SYDNEY NORTH PLANNING PANEL COUNCIL ASSESSMENT REPORT

Panel Reference	PPSSNH-321
DA Number	DA2022/1000
LGA	Northern Beaches
Proposed Development	Demolition works, alterations and additions to existing buildings and construction of new mixed-use buildings
Street Address	Lot 100 DP 1276056 and Lot 101 DP 1247422 19 - 21 South Steyne and 22 Wentworth Street, MANLY NSW 2095
Applicant/Owner	Royal Far West Royal Far West Children's Health Scheme
Date of DA lodgement	30/06/2022
Number of Submissions	6
Recommendation	Approval
Regional Development Criteria (Schedule 7 of the SEPP (State and Regional Development) 2011)	Capital Investment Value (CIV) >\$30 Million The CIV of the development being \$103,708,679.
List of all relevant s4.15(1) (a) matters	<ul style="list-style-type: none"> • Environmental Planning and Assessment Act 1979 • Environmental Planning and Assessment Regulation 2021 • State Environmental Planning Policy (Hazards and Resilience) 2021 • State Environmental Planning Policy (Building Sustainability Index: BASIX) • State Environmental Planning Policy (Transport and Infrastructure) 2021 • State Environmental Planning Policy No 65 – Design Quality of Residential apartment De

Figure above - Extract from applicant's addendum SEE showing how privacy mitigated between Building C and 29 Victoria Parade.

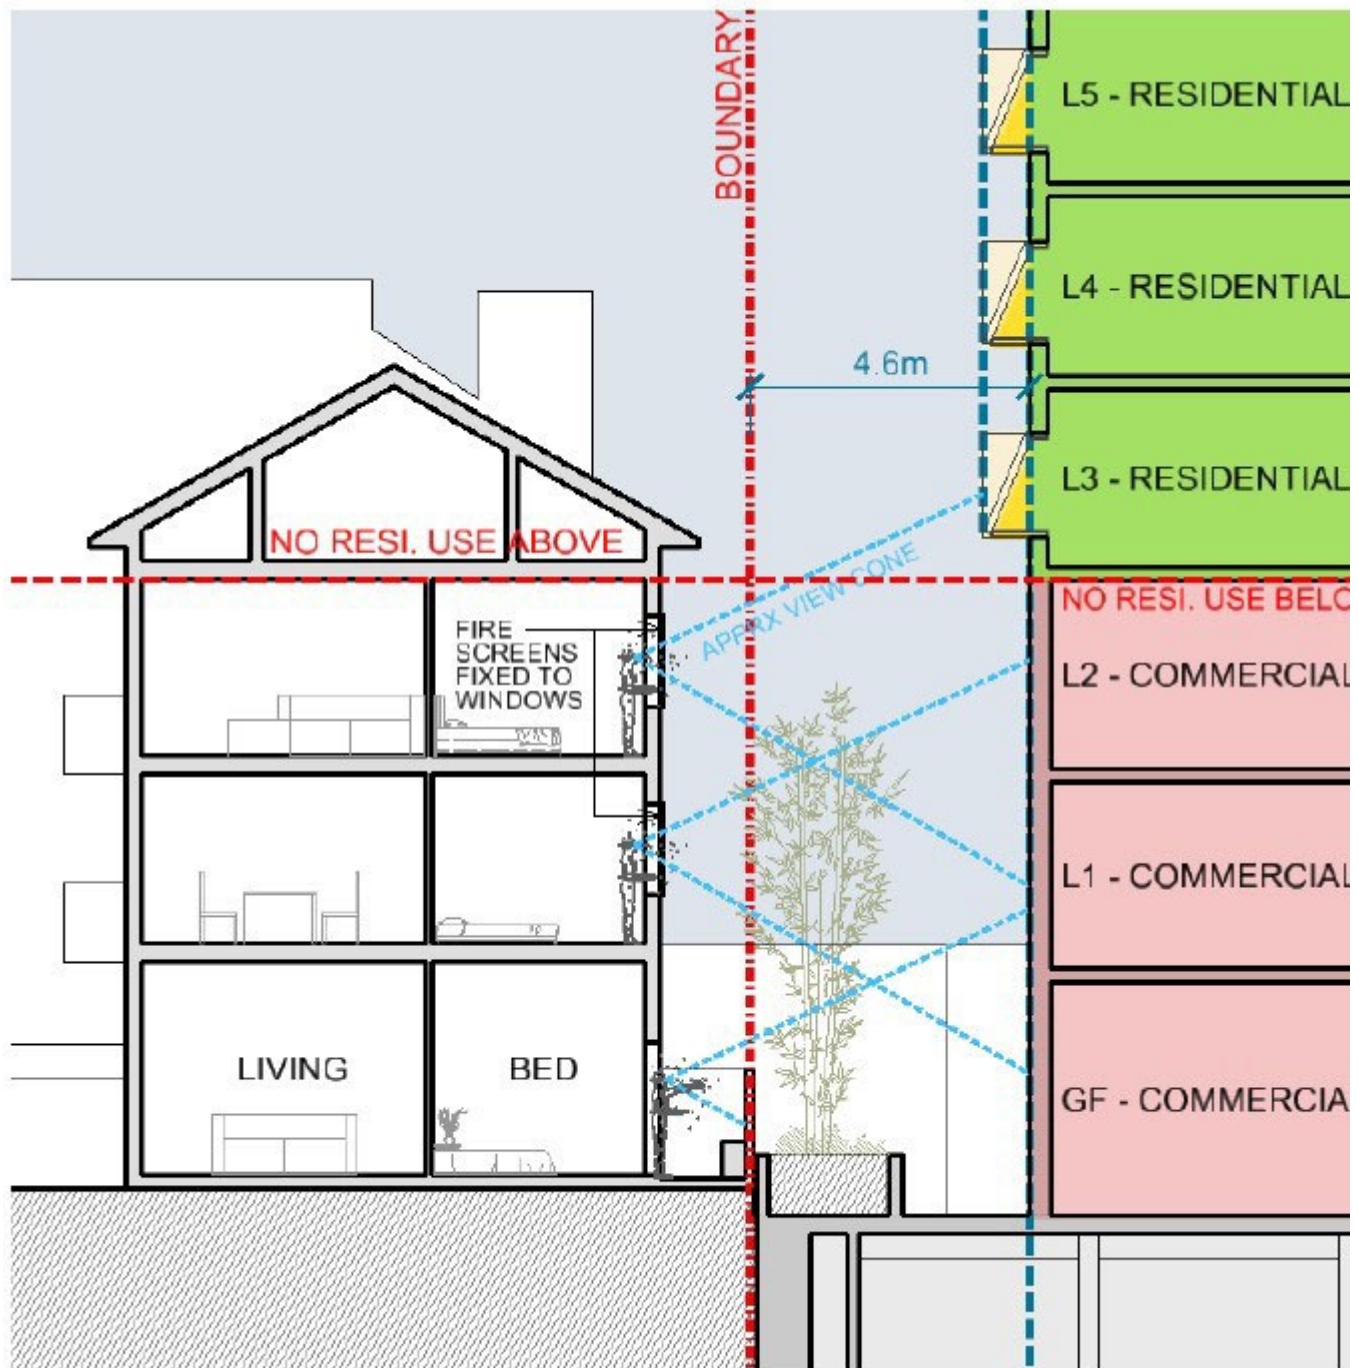
The communal open space on Building C is located to the northern extent of the building to limit any direct overlooking of the adjoining sites.

Overall, the development has considered the retention of privacy for the adjoining properties and uses a variety of methods to mitigate views between properties.

Figure 2 - Marked up plan showing building location relative to the substation, based on the proposed setbacks. Mark ups prepared by the assessing officer.

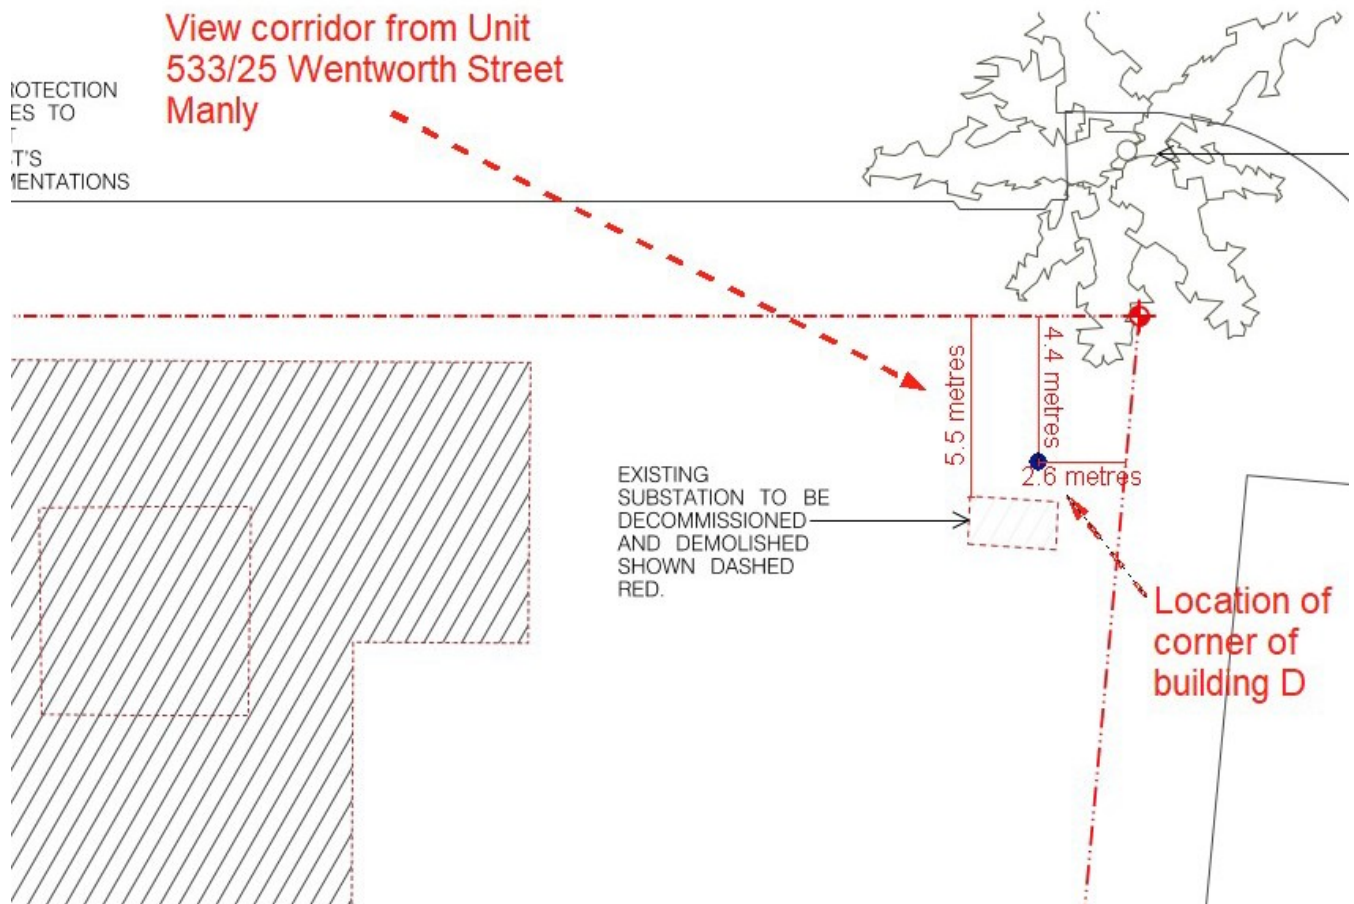
For Unit 533/25 Wentworth Street, the views are obtained from the balcony (figure 3), the living room (figure 4) and the bedroom (figure 5). All views are obtained from the front boundary of the affected property, the street address being Wentworth Street for Unit 533/25. Views from the balcony are obtained from a seated and standing position. Views from the living room are obtained in a standing position, however once seated, the water view becomes more obscured because of the balcony balustrade. Views from the bedroom are obtained in a standing position, however once seated, the water view becomes more obscured because of the balcony balustrade.

Unit 533/25 Wentworth Street - The views which are shown in figure 3, 4 and 5 are the total views available from the property. The view of Manly Beach is obscured by the heritage listed trees, however, is still good quality containing Manly Beach and the wave action zone. The view of Shelly Beach and Fairy Bower is highly obscured by the heritage listed trees and is considered low quality, as these landmarks are very obscured. From the living room and the balcony, approximately 50% of the view will be obscured and this considered to be a moderate impact, given the fact the view is already partially obscured by vegetation and around 50% of the view will be retained (and will be retained in the future given the public road will not be redeveloped). The portion of view from the bedroom will have between 40%-50% impacted (the bedroom being east of the living rooms, therefore a wider corridor available), with the portions of water view impacted obscured by the existing heritage trees. Therefore, the view impact is moderate for this room as well.

Figure 6: Overlay diagram of the S7SW Concept envelopes with the proposed detailed DA design (NW corner of Building D).

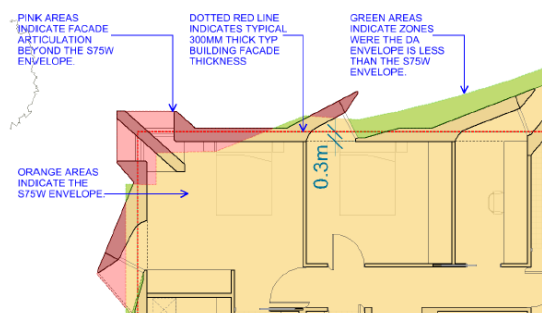
There is a minor difference in the proposed setback arrangement to Wentworth Street for Building D, which the applicant has prepared the following diagram and explanation below:
